Project Name:	Coldharbour Farm Road, Emsworth
Document Reference:	187.0018/TN/2
Document Name:	Transport Note
Prepared By:	Mark Smith (May 2026)
Checked By:	Mark Smith (May 2026)
Approved By:	Mark Smith (May 2026)

Designers Response Road Safety Audit
Coldharbour Farm

Road Safety Audit Report

Proposed Continuation of Coldharbour Farm Road Emsworth

DISCLAIMER NOTES:

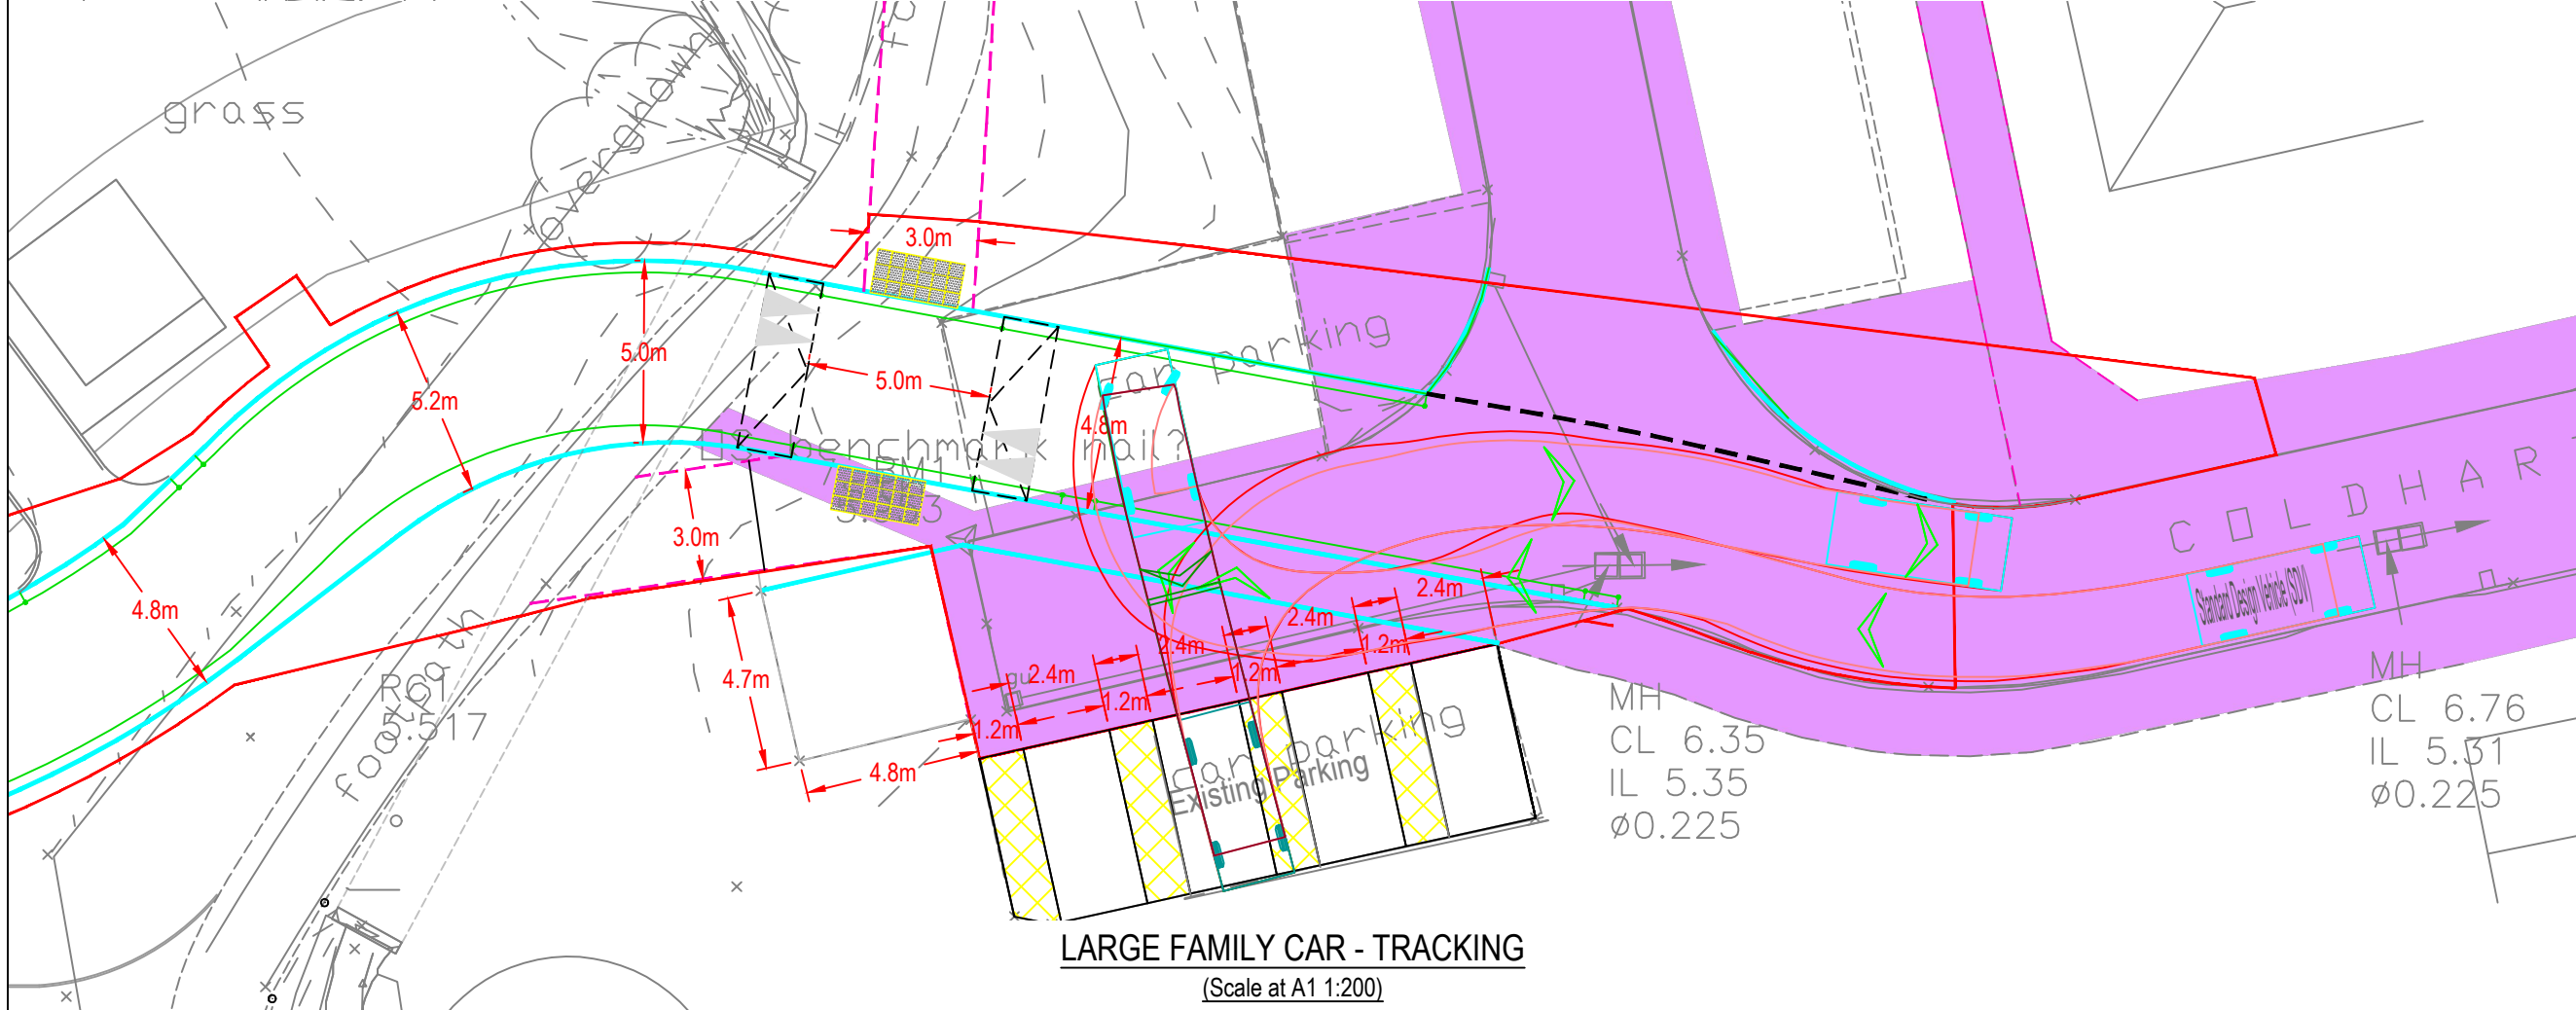
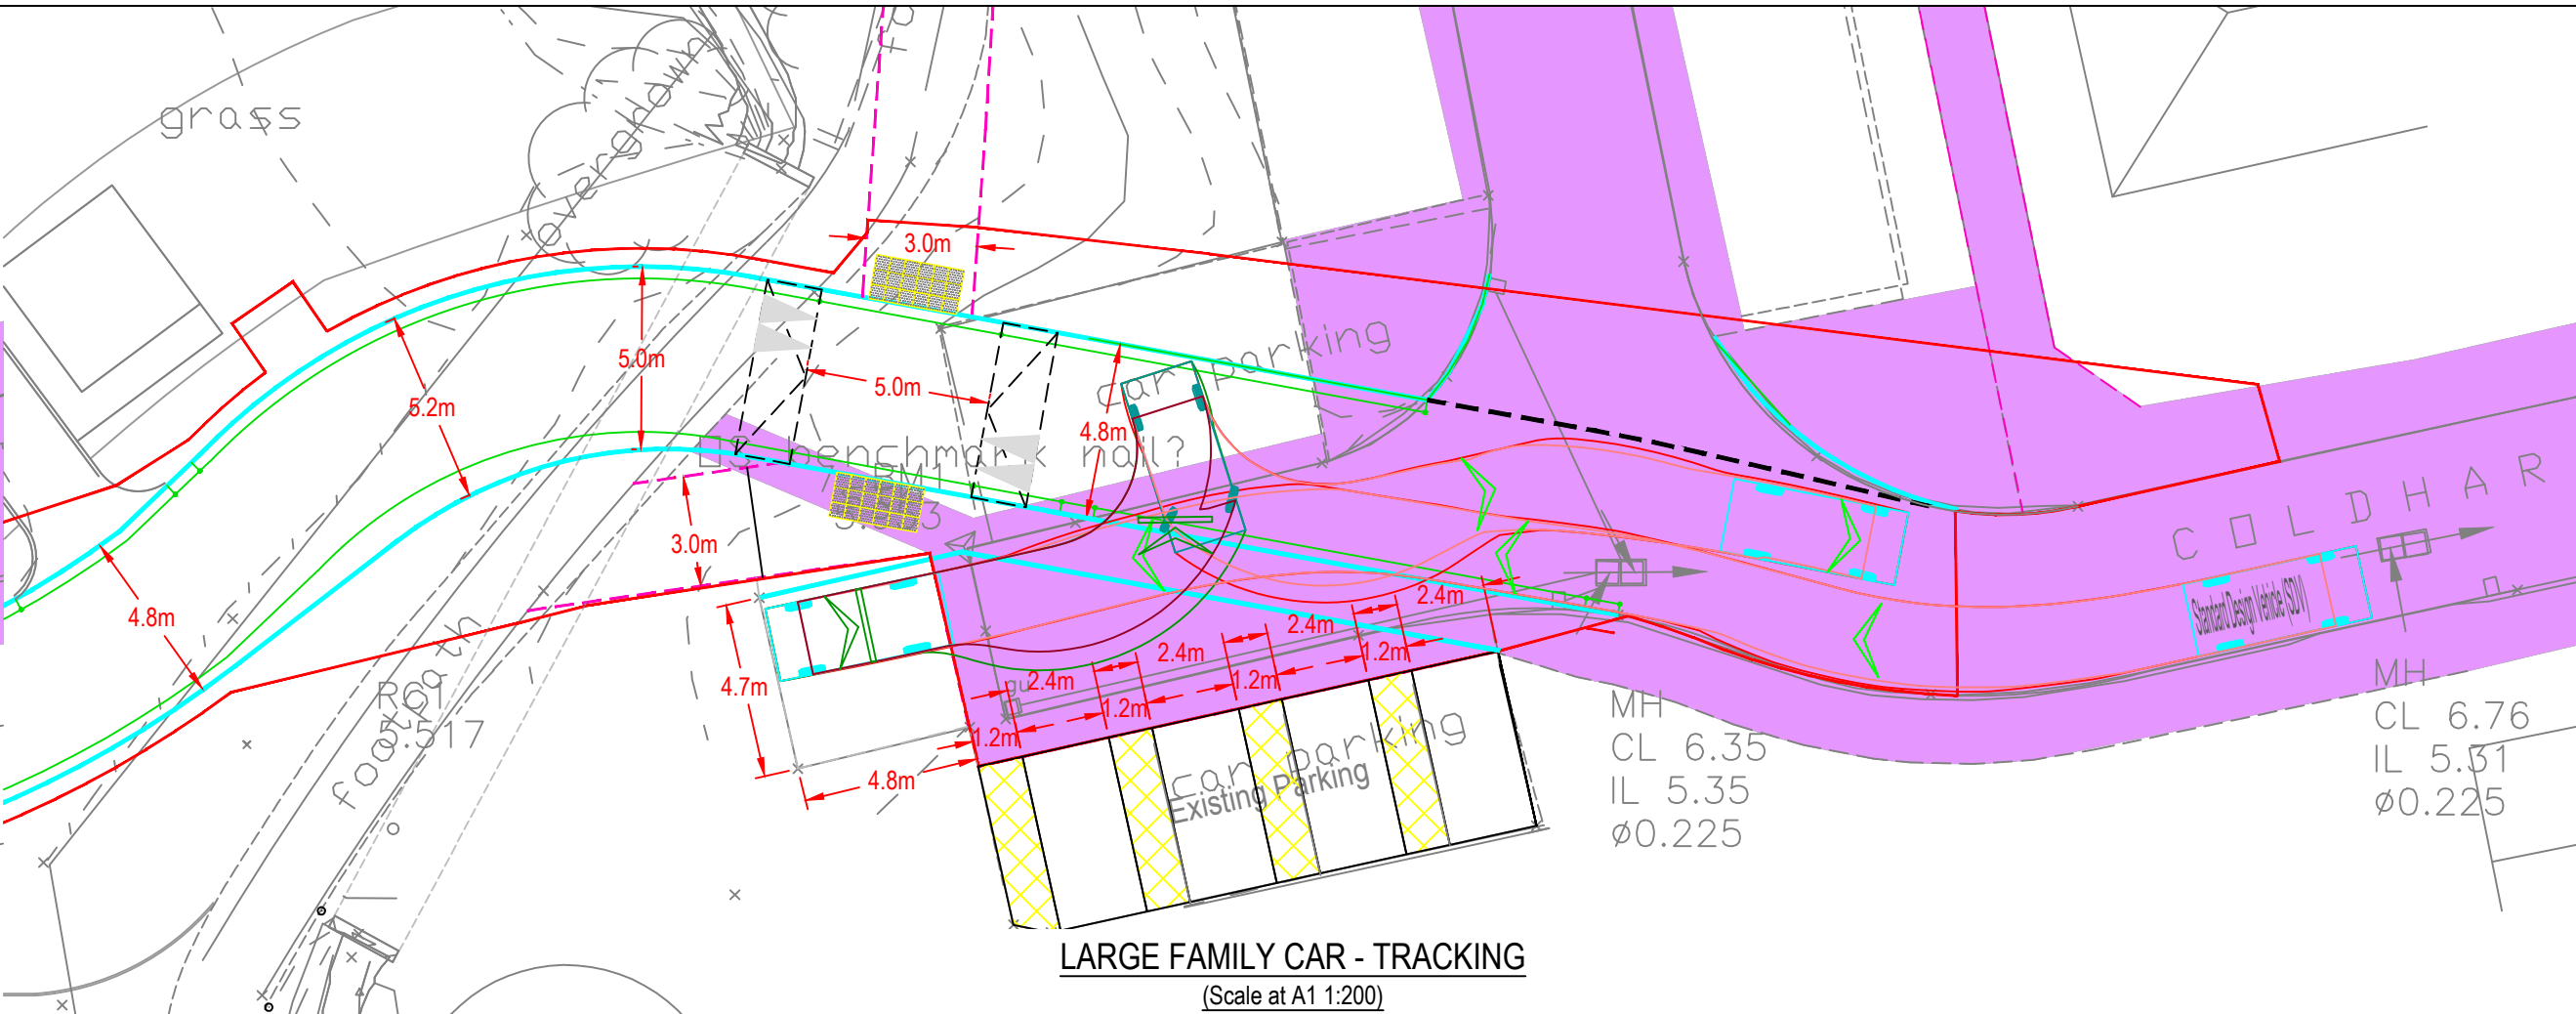
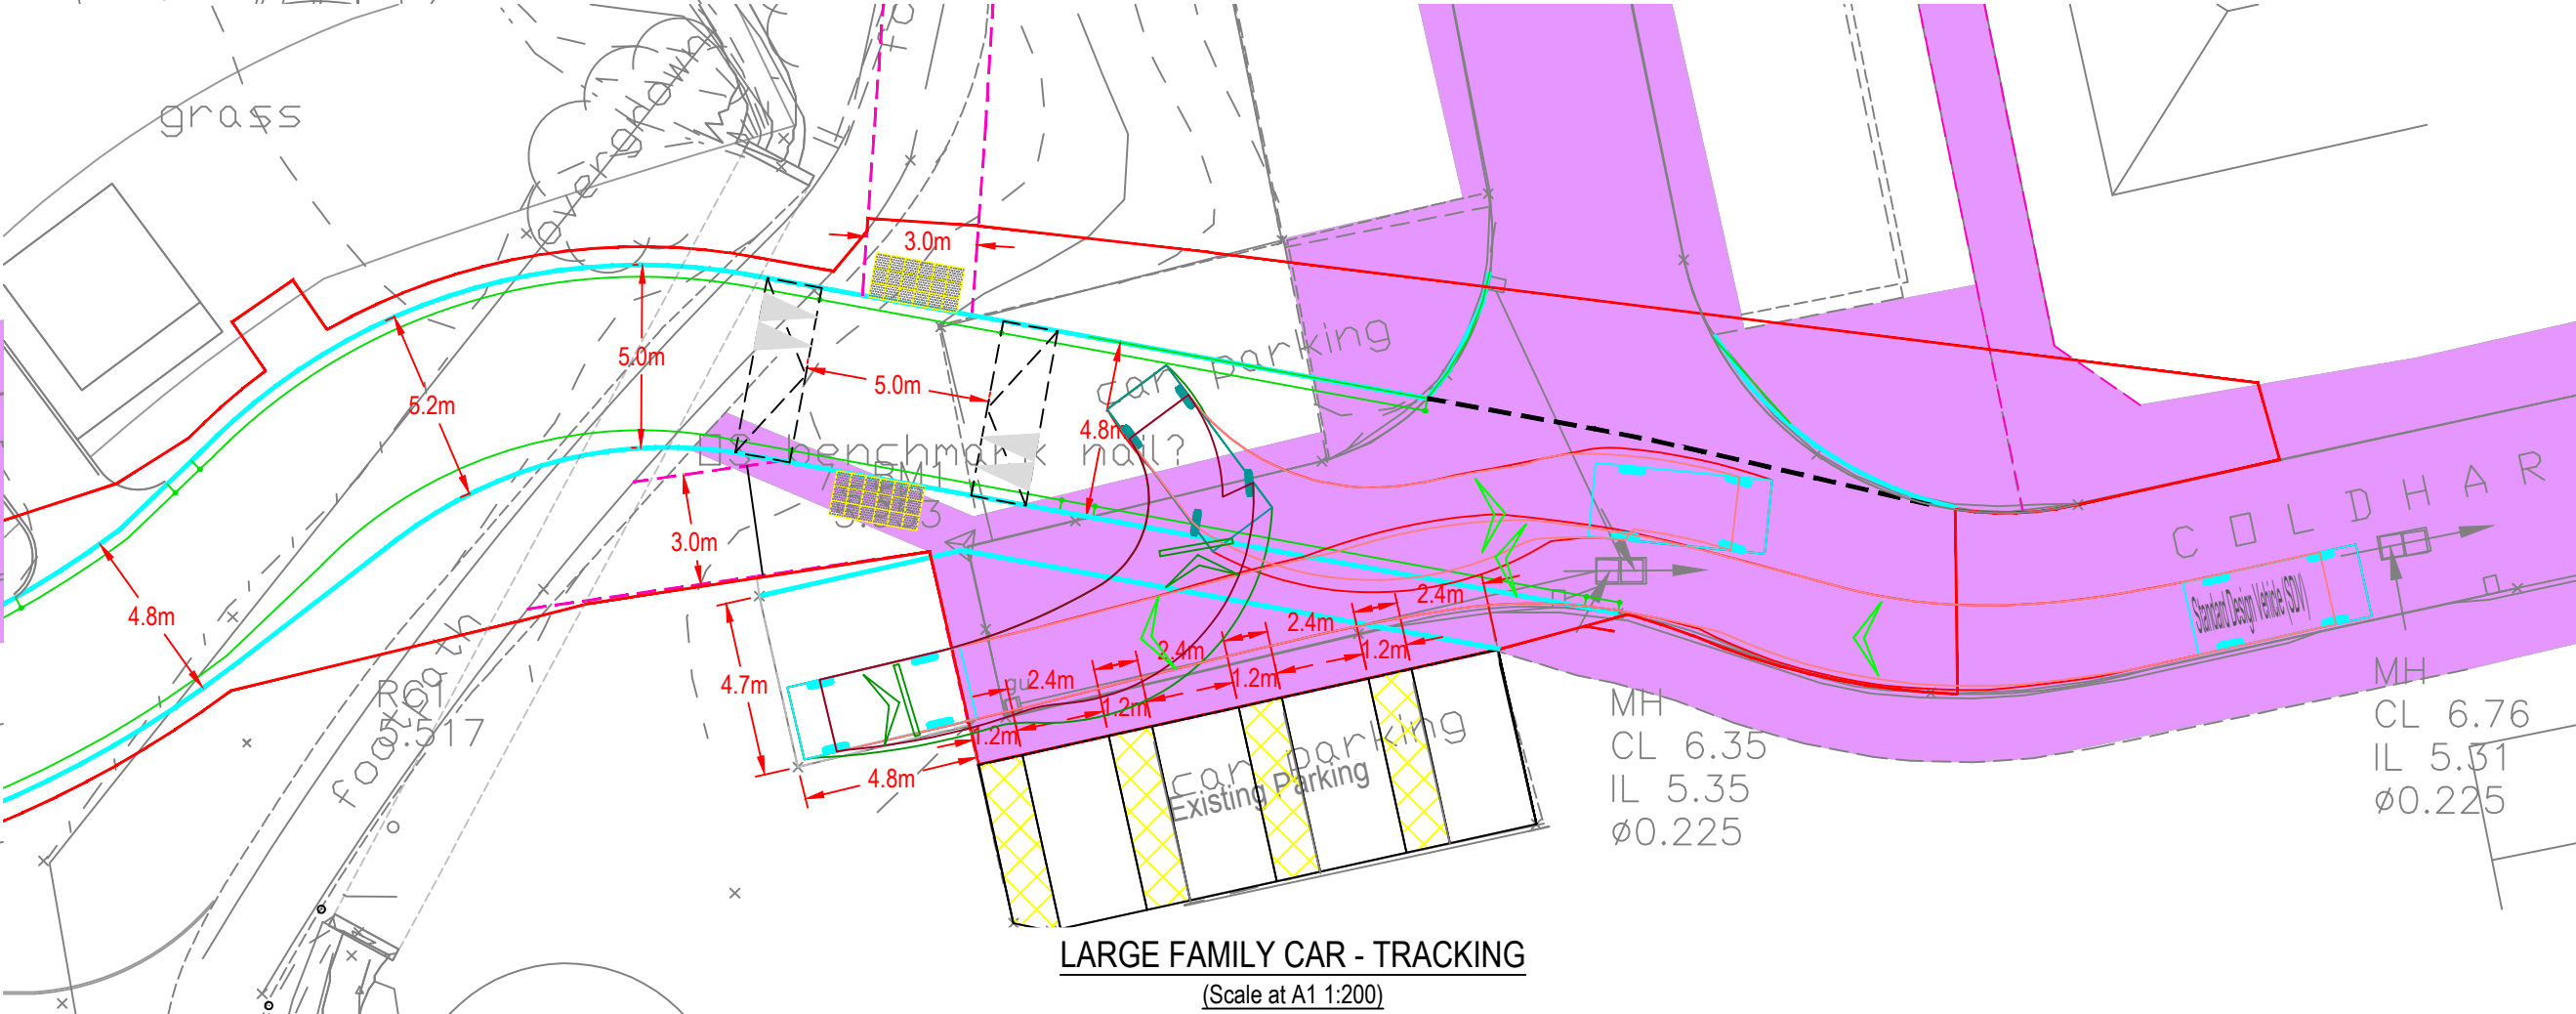
B.1.1 – Alignment may not be adequate for two-way car / LGV movements. It is recommended that the carriageway is adequate for cars and LGVs to pass one another.

We have provided updated tracking Drawing 23339-JUBB-XX-XX-DR-X-001200 REV C4 that shows in the bottom right that cars can pass each other.

DRAWING No: JUBB_XX_XX_DR_C_1203

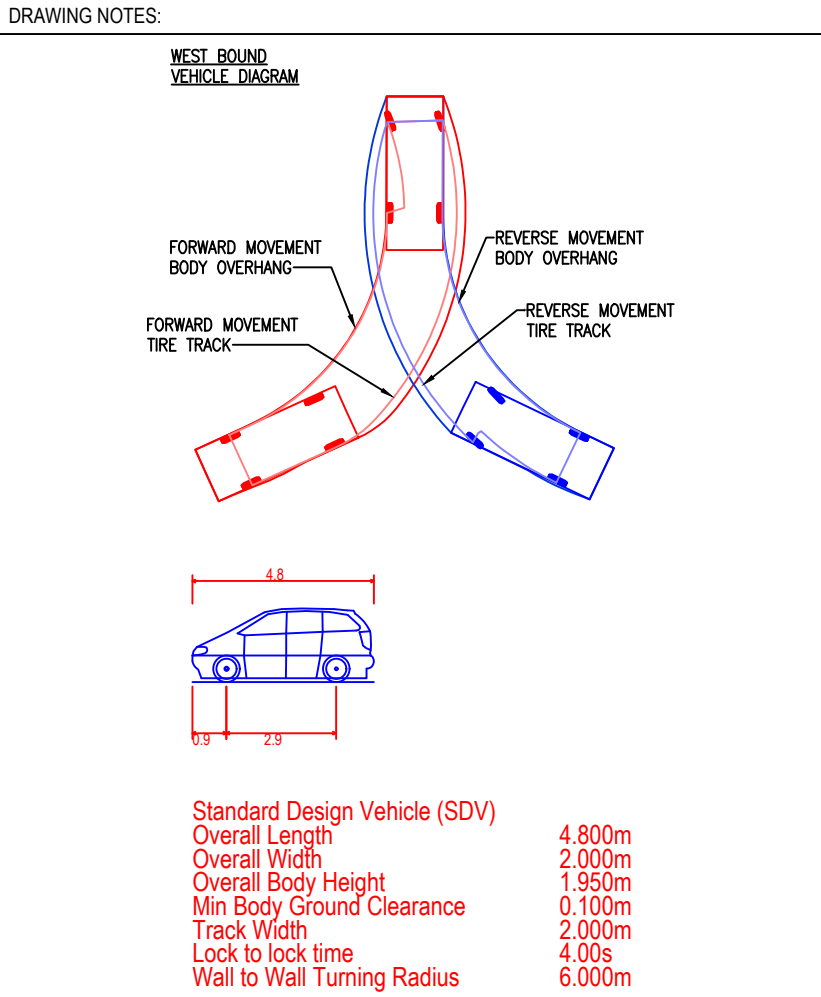
B2.2 Vehicles may not be able to access the existing parking bays. It is recommended that the bays are accessible.

The existing parking bays are proposed to be relined as shown on Drawing 23339-JUBB-XX-XX-DR-X-000100 REV C13 and the tracking is shown on Drawing 23339-JUBB-XX-XX-DR-X-001203 REV C1.

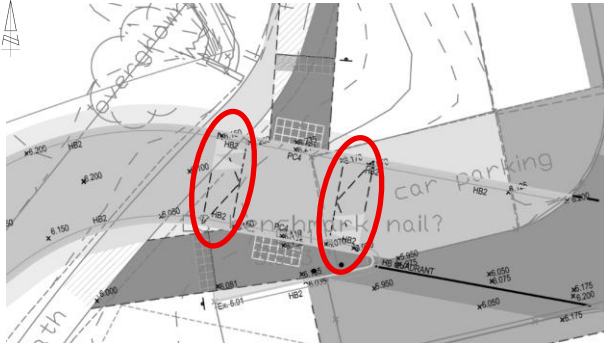
RECOMMENDATION:	
It is recommended that the carriageway is adequate for cars and LGVs to pass one another.	
Location Plan:  	
B.2	GENERAL
B.2.1	PROBLEM
Location:	Proposed continuation
Summary:	No details of the proposed raised table have been provided
Acc Type:	Vehicle to non-motorised user, sideswipe type collisions
<p>The proposals include the provision of an uncontrolled crossing over the proposed access road that is to be situated on a raised table. Whilst the provision of a raised table should ensure that motorists reduce their speed on approach, no details of the associated ramps have been provided. The Audit Team have concerns that the proposed raised table will be too shallow which will not</p>

It is recommended that the proposed raised table includes adequate ramps that force traffic slow.

The raised table ramp length has been designed in accordance with HCC detail HCC11/C/105 Rev B.

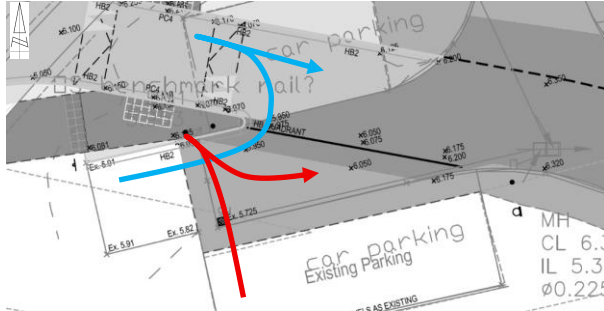
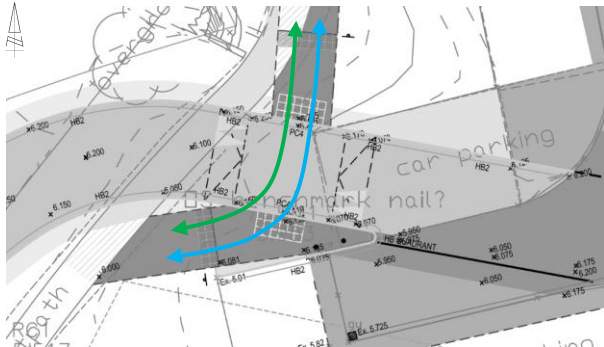
B.2.2	PROBLEM
Location:	Coldharbour Farm Road
Summary:	Vehicles may not be able to access the existing parking bays.
Acc Type:	Side impact type collision

The proposals include the continuation of Coldharbour Farm Road where a number of parking bays are provided both sides of the carriageway. The existing parking cul-de-sac off the northern side is to remain largely unchanged with a 6.0 metre aisle that allows for easy access to each bay and an edge of carriageway marking provided which will highlight priorities. It is noted, however, that the parking bays to the south of Coldharbour Farm Road do not benefit from an aisle that is of adequate width to allow a car to turn (6 metres). Motorists wishing to access the existing bays, will therefore be required to reverse off or onto the Coldharbour Farm Road carriageway. Speeds will be low and therefore motorists should become aware of one another and proceed accordingly. The Audit Team have concerns, however, that a vehicle will be required to encroach the proposed uncontrolled crossing or shared footway cycleway when manoeuvring into / out of the existing spaces which could lead to vehicle to non-motorised user type collisions.

It is recommended that the bays are accessible.

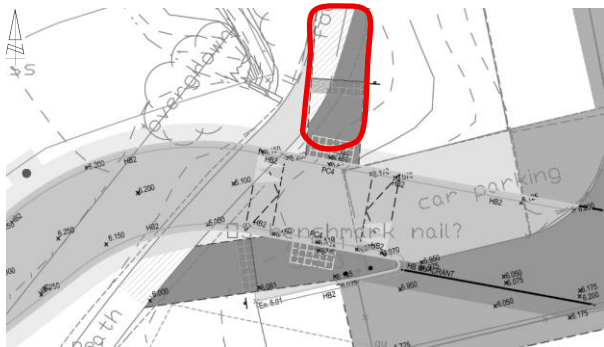
RECOMMENDATION:	
It is recommended that an appropriate level of visibility is achievable.	
<p>Location Plan:</p>  	
B.4.2	PROBLEM
Location:	Coldharbour Farm Road
Summary:	Non-motorised users at and on approach to the uncontrolled crossing may not be clearly visible during the hours of darkness
Acc Type:	Vehicle to pedestrian type collisions
<p>The public footpath 108/71/1 that is present to the west of the Coldharbour Farm Road cul-de-sac provides a link between the facilities available at Emsworth Park and the residential areas to the south. During the site visits associated with this scheme, numerous pedestrians to include joggers and cyclists have been observed. The proposals include the continuation of Coldharbour Farm</p>

<p>Road to the west severing the existing footpath. As part of the proposals, an uncontrolled crossing is to be provided on a raised table. This crossing is to benefit from tactile paving to a depth of 1200mm which should be sufficient to warn all pedestrians of the live carriageway. The scheme drawing illustrates that visibility splays of 2.4x43 metres are achievable from the uncontrolled crossing, however, they do not extend to the tangent and it is noted that the footpath is not illuminated. The Audit Team have concerns that visibility of a non-motorised users immediately approaching the proposed uncontrolled crossing is limited, particularly during the hours of darkness which could lead to a vehicle to pedestrian type collision.</p>

<p>RECOMMENDATION:</p>	
<p>It is recommended that visibility is achievable to the tangent and that the proposed crossing point is illuminated adequately with a column provided immediately to the west of the crossing point as previously proposed.</p>	
<p>Location Plan:</p> <div></div>	
<p>B.5</p>	<p>TRAFFIC SIGNS, CARRIAGEWAY MARKINGS AND LIGHTING</p>
	<p><i>No Road Safety Concerns regarding TRAFFIC SIGNS, CARRIAGEWAY MARKINGS AND LIGHTING have been raised at this stage</i></p>
